RE: 7-AB-2021 Response Letter
Carder Abandonment
1992A (Key Code)

Dear Desirae: Please see the following **responses** to the 1st review letter dated 11/29/2021.

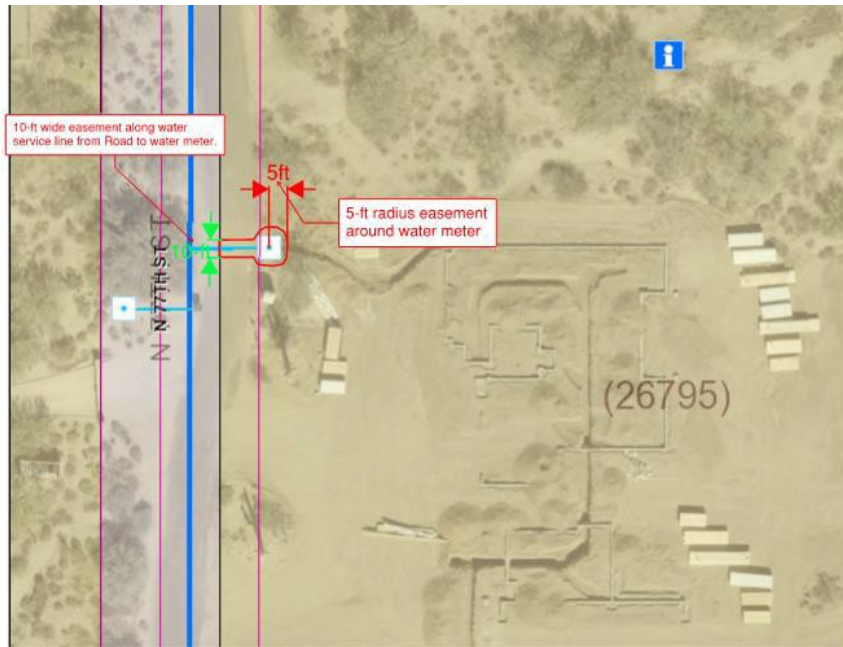
1. Abandoning 33-ft of GLOPE and dedicating a 15-ft of water and sewer easement along north property line is acceptable to Water Resources.
2. Abandoning 13-ft of GLOPE along west property line is acceptable to Water Resources. However, abandonment of 13-ft of GLOPE along west frontage would require relocation of the water meter at Owner's expense.
 - a. Owner has requested whether a dedication of additional easement for the water meter and service line would be acceptable with Water Resources:
 - i. Water Resources would require 10-ft wide water easement along water service line from N 77th St to existing water meter and 5-ft radius water easement around the water meter per screenshot below:

- ii. 7-AB-2021_1-Water_Sewer Easement_8-30-21 Exhibit does not reflect the water easement requested above in Section 3.a.i.

Response: See updated legal description with water meter area added to easement.
